## ADDENDUM NO. FIVE (5)

**Project:** Harold D. Thompson Regional Water Reclamation Facility  
Phase 1 – 2.5 MGD

**Date of Addendum:** July 7, 2011

**Owner:** Lower Fountain Metropolitan Sewage Disposal District

**SC-2**  
OF  
—

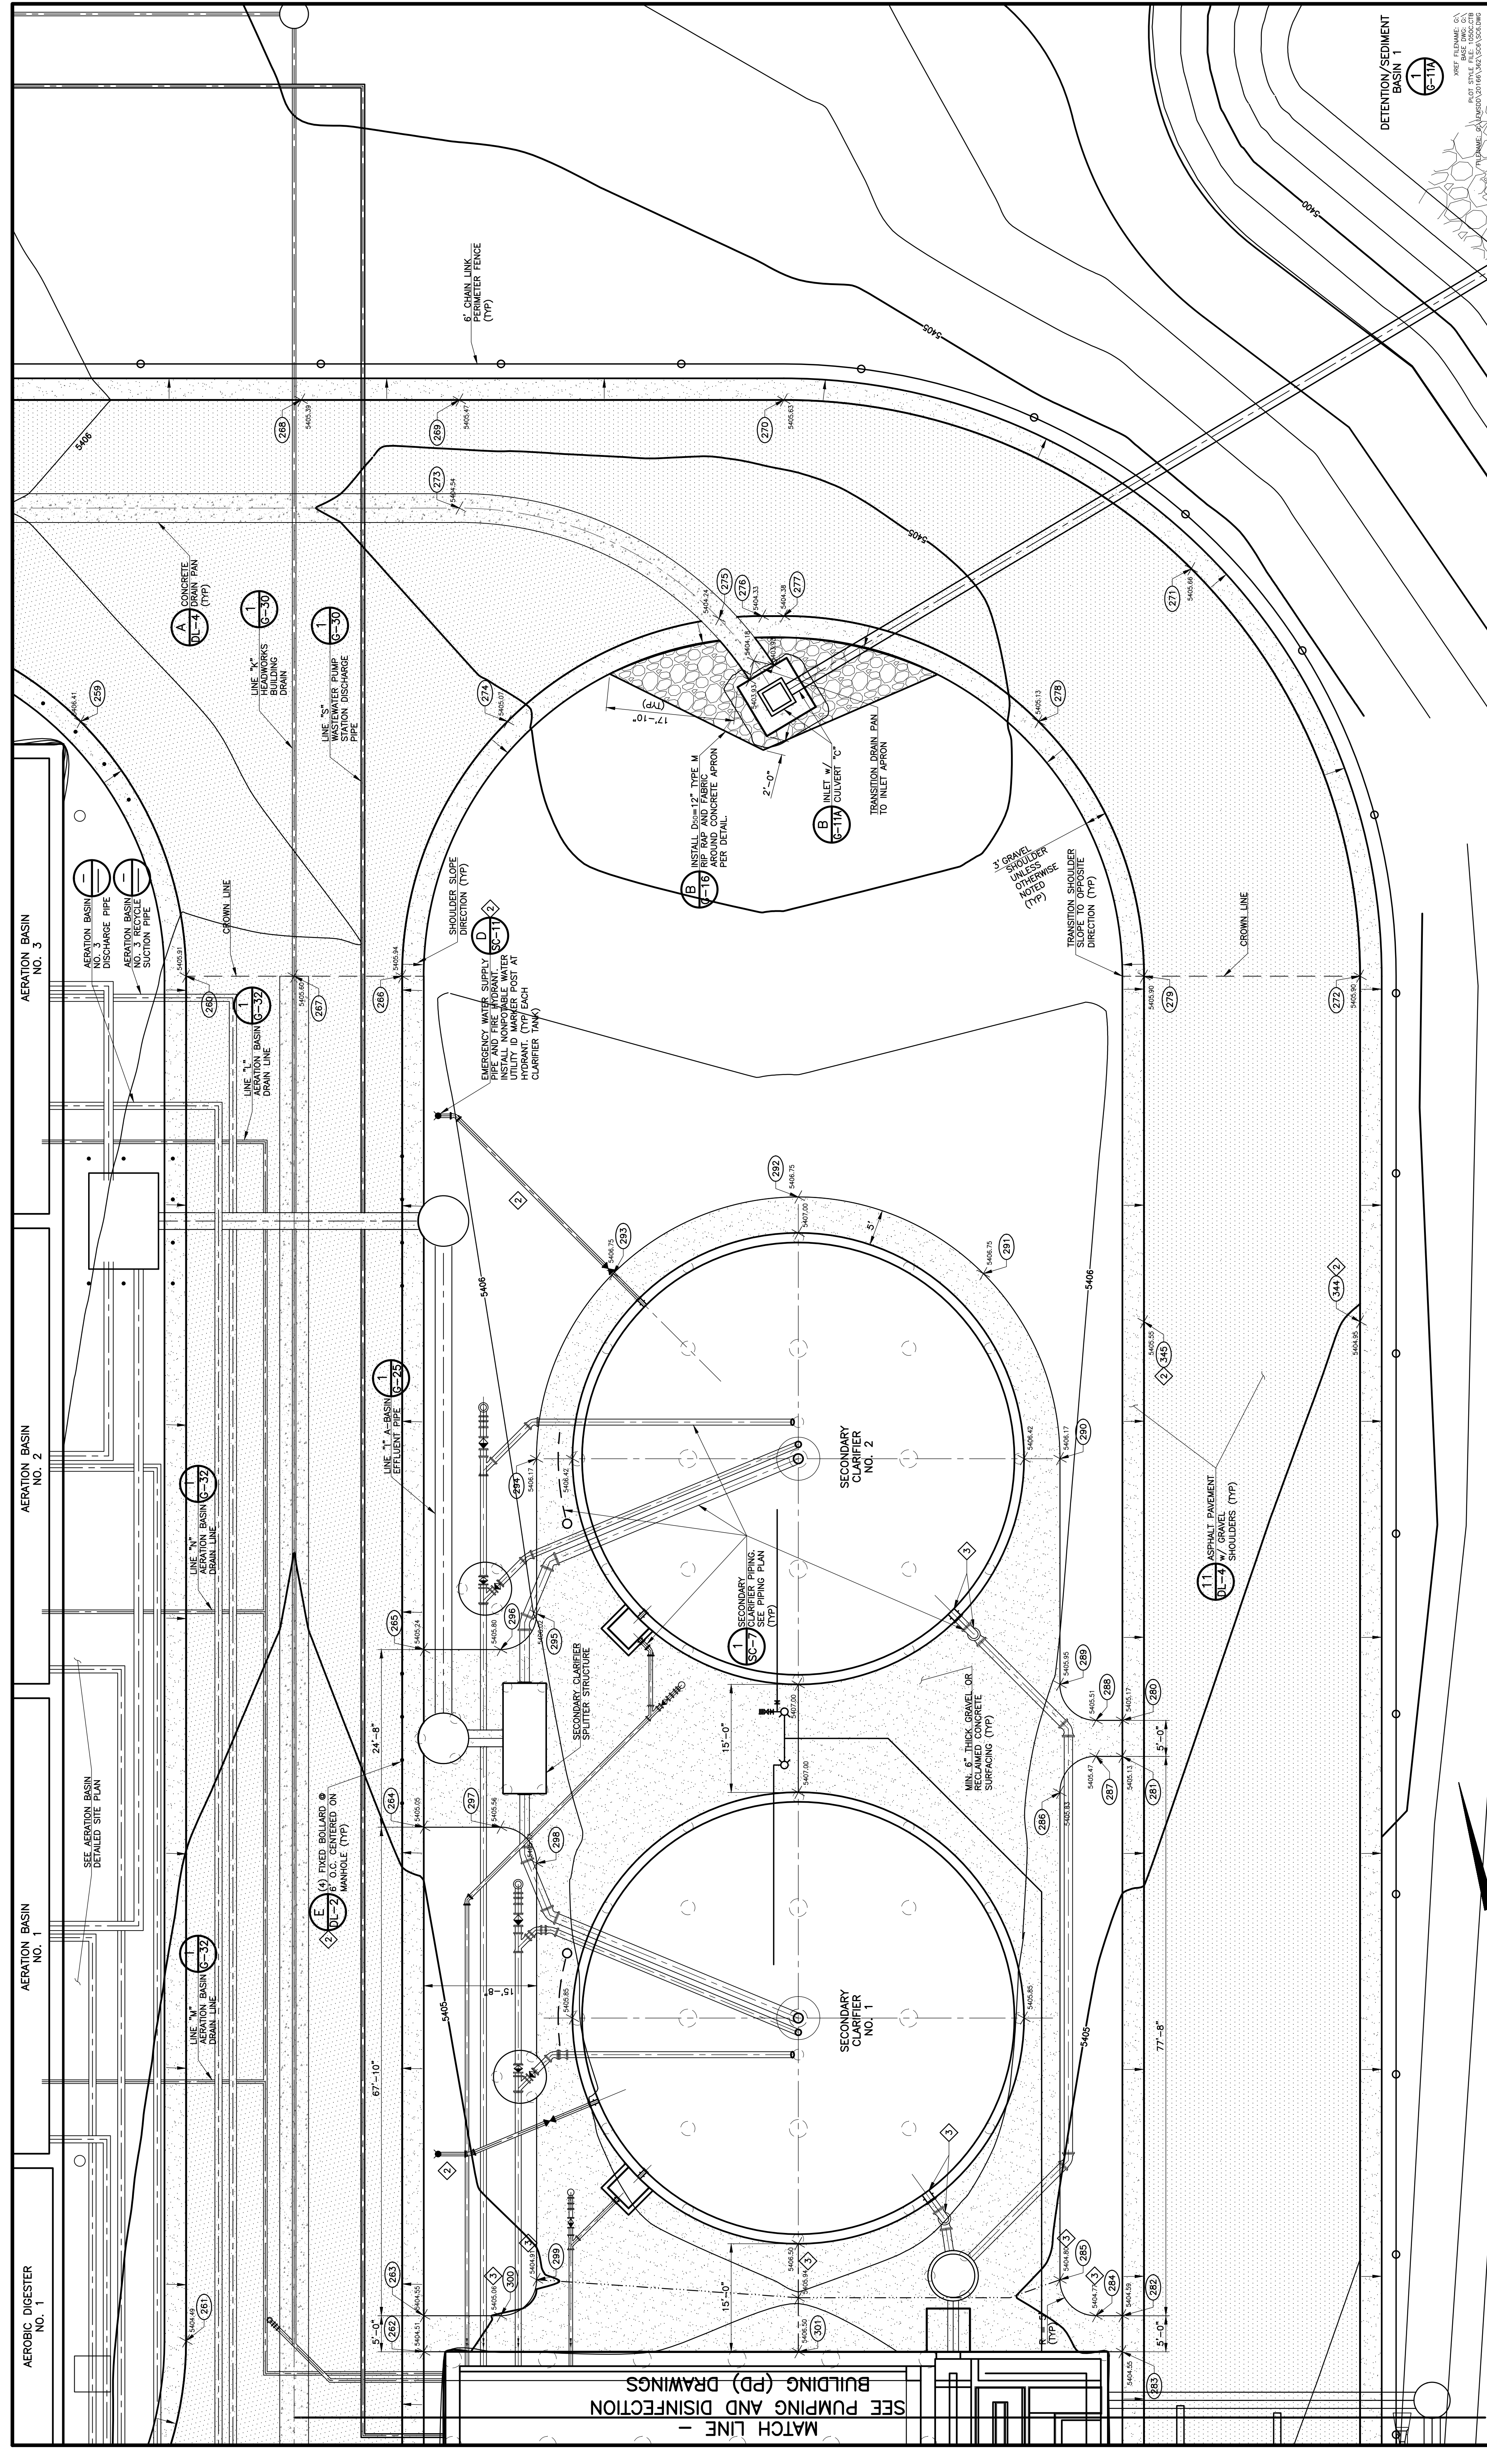
3.01 **REVISE** the secondary clarifier effluent pipe size to 14-inch diameter on the following Drawings:

- A. **CLARIFICATION:** This Addendum No. Five (5) revises the size of the secondary clarifier effluent pipes from 12-inch diameter to 14-inch diameter to optimize the accommodations in the Pumping and Disinfection building for the UV disinfection channels and equipment. There are two secondary clarifier effluent pipes affected by this Addendum No. Five (5), one from each clarifier running to the east/southeast of the clarifiers. WGCC was verbally notified of this change on June 21, 2011 so they can properly adjust the size of the wall pipes that are to be cast into the clarifier walls.

SHEET **SC-9** OF 1

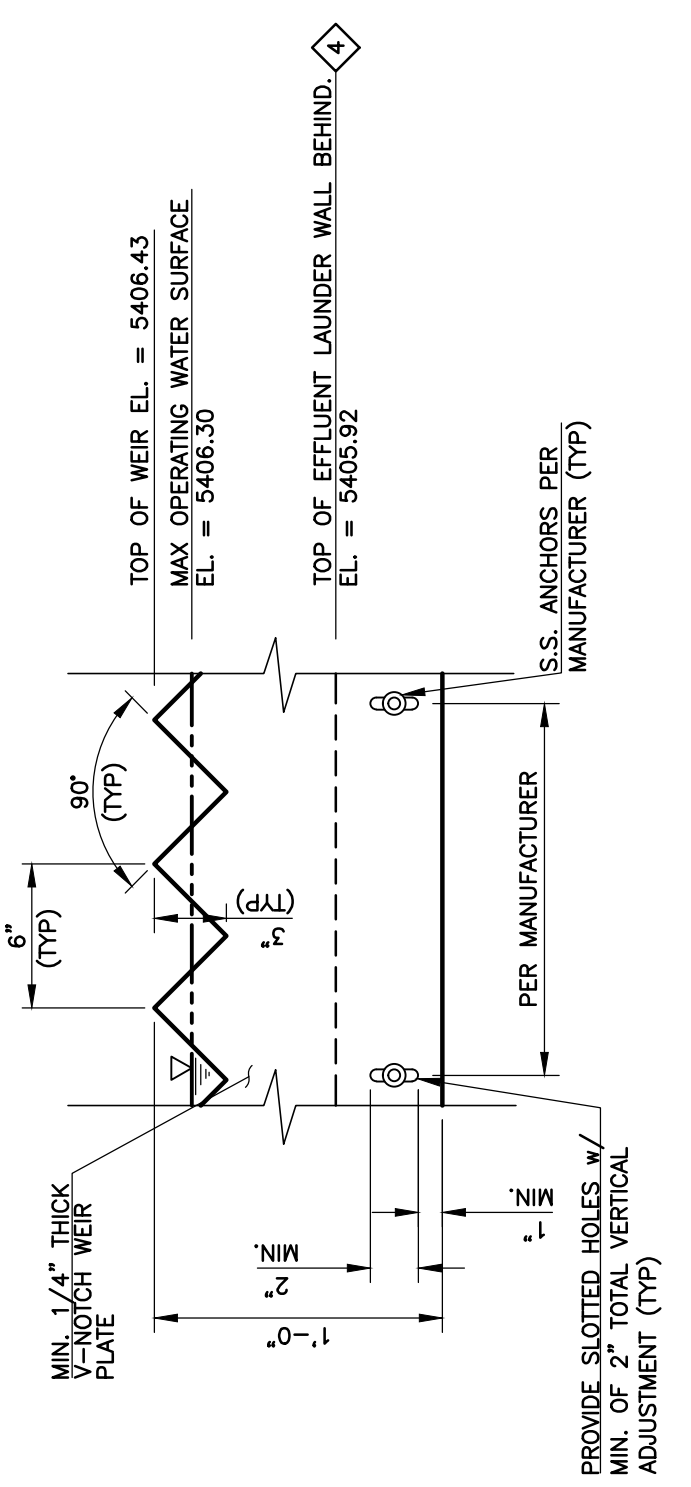
1. **REVISE** Section B to indicate a top of effluent launder wall (behind) elevation of 5405.92.
